UNITED STATES DEPARTMENT OF COMMERCE United States Patent and Trademark Office Address: COMMISSIONER FOR PATENTS P.O. Box 1450 Alexandria, Virginia 22313-1450 www.uspto.gov

APPLICATION NO.	FILING DATE	FIRST NAMED INVENTOR	ATTORNEY DOCKET NO.	CONFIRMATION NO.
10/700,292	11/03/2003	Phillip M. Gibbs	5490-000224/US/CPB	6515
<sup>27572</sup> HARNESS, DI	7590 10/31/2007 CKEY & PIERCE, P.L.C.		EXAMINER	
P.O. BOX 828			RAMANA, ANURADHA	
BLOOMFIELI	D HILLS, MI 48303		ART UNIT PAPER NUMBER	
	•		3733	
			MAIL DATE	DELIVERY MODE
			10/31/2007	PAPER

Application No.	Applicant(s)
		10/700,292	GIBBS, PHILLIP M.
•	Office Action Summary	Examiner	Art Unit
		Anu Ramana	3733
Period fo	The MAILING DATE of this communication app or Reply	ears on the cover sheet with the c	orrespondence address
A SHO WHIC - Exter after - If NO - Failur Any r	ORTENED STATUTORY PERIOD FOR REPLY CHEVER IS LONGER, FROM THE MAILING DATES as ions of time may be available under the provisions of 37 CFR 1.13 SIX (6) MONTHS from the mailing date of this communication. Period for reply is specified above, the maximum statutory period were to reply within the set or extended period for reply will, by statute, eply received by the

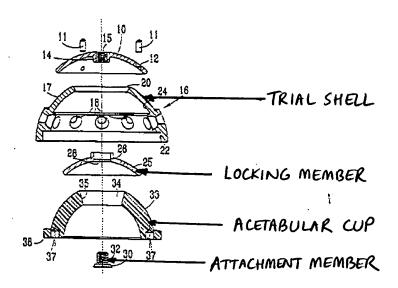
Claims 16-23 and 25-32 are rejected under 35 U.S.C. 102(e) as being anticipated by Doursounian et al. (US 6,527,809).

Doursounian et al. disclose a system including: a trial shell including an attachment device or hole therein; an acetabular cup 33; an attachment member 30; and a locking member 25 to operably couple the attachment member to the trial shell (Fig. 2, col. 2, lines 54-67 and cols. 3-4). See Fig. 2 below, marked up to show elements of Applicant's invention.

The method steps of claims 23 and 25-32 are inherently performed when the Doursonian et al. system is trialed to determine the final stable orientation.
